PRODUCT CHANGE NOTIFICATION

#PCN-DCT-TKXB-10

Business Unit	Product Line Code	Type of Change	Action	Date of issue
DCT	210	Mechanical	Notify Distributors and Field	07/07/2010

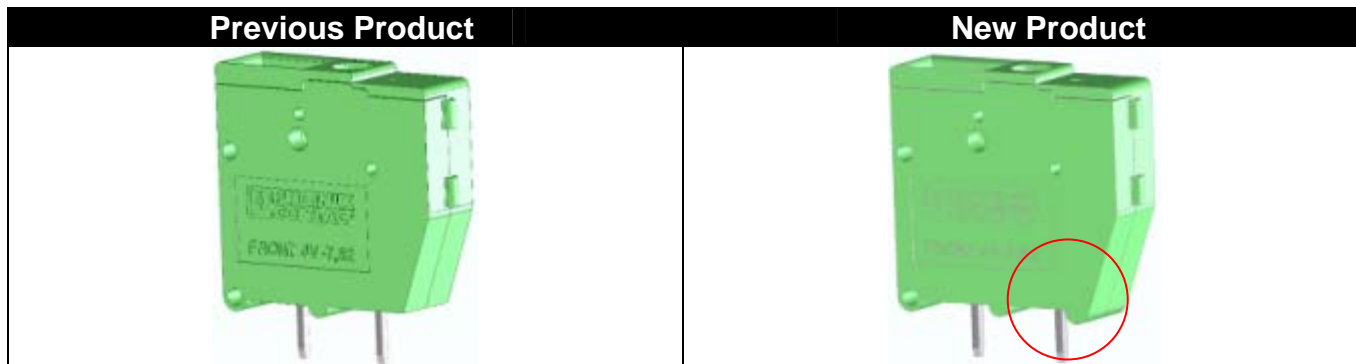
To improve the stability of the Front 4-V-7,62 type terminal blocks on the PCB, the contact area on the bottom side of the block is being changed to include an additional plastic rib. Technical data will remain the same.
